**Terminology around DWDM systems and
relation with ITU-T SG15 Recommendations.
Author's understanding of outcome meeting 28 January**

Peter Stassar, Huawei

IEEE P802.3ct Task Force, Interim Teleconference Meeting, 4 February 2021

Name for the grey box in Figure 154-3

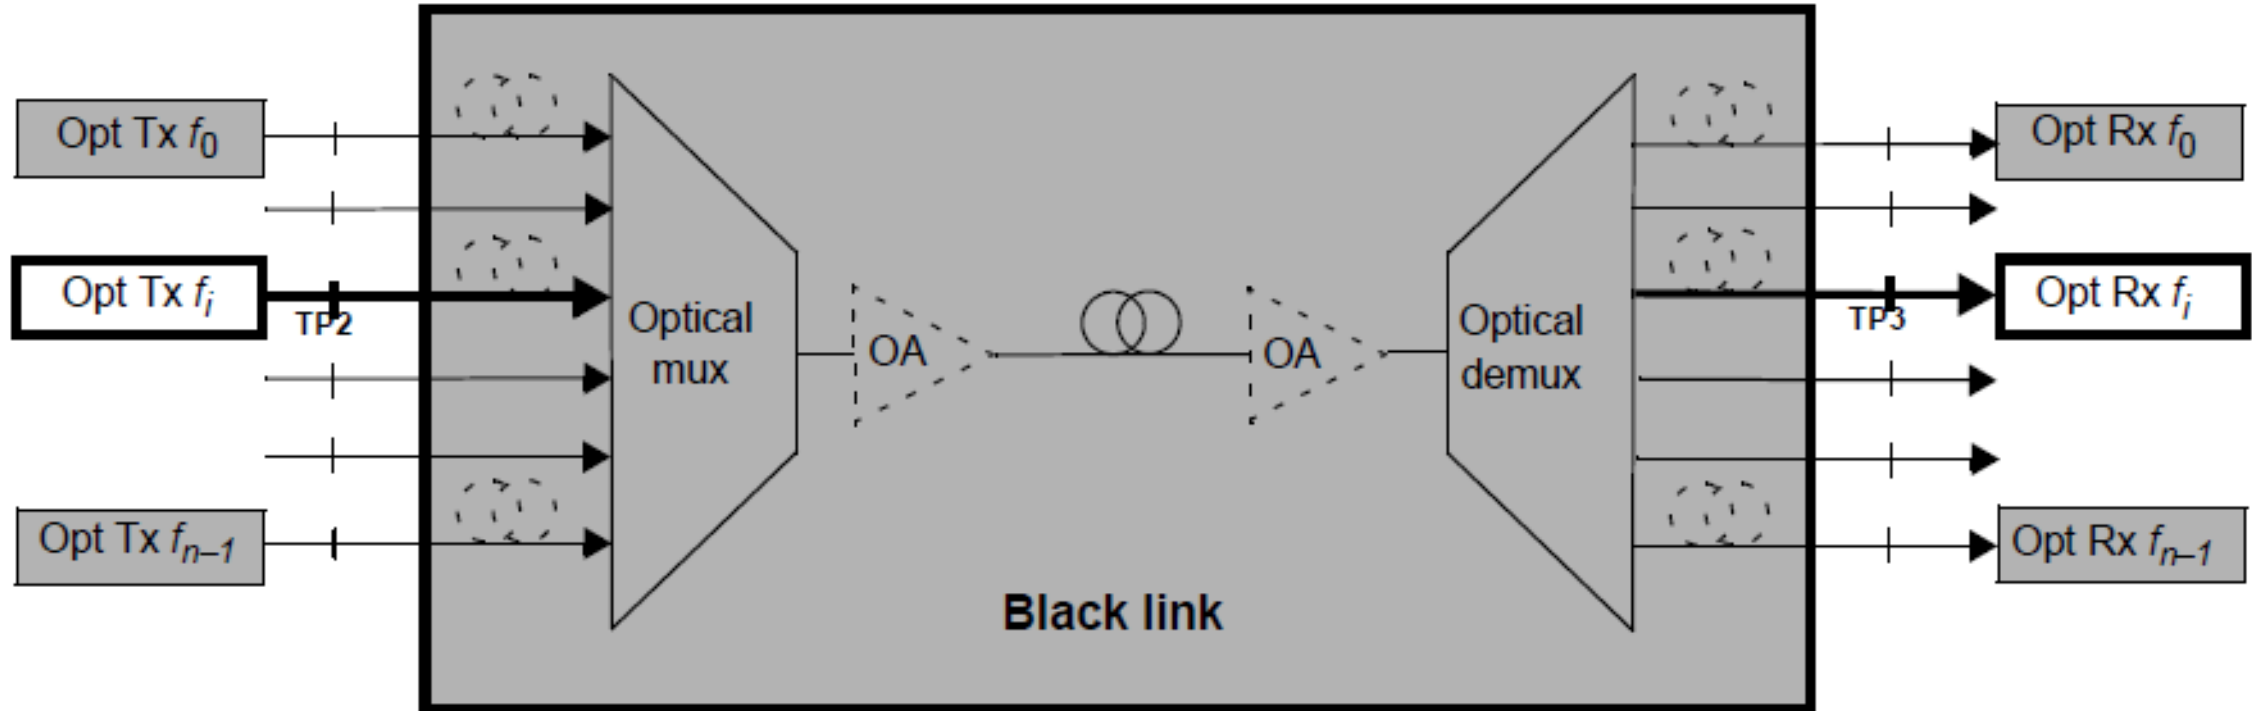
Concerns remain on usage of term “black link” compared to the definition of “link” in IEEE Std 802.3™-2018.

This could be seen not inconsistent with a definition of DWDM black link between multiple TP2 and multiple TP3.

The Task Force could consider to use the term “DWDM black link” for the grey box and replace “black link” with “DWDM black link” in Clause 154.
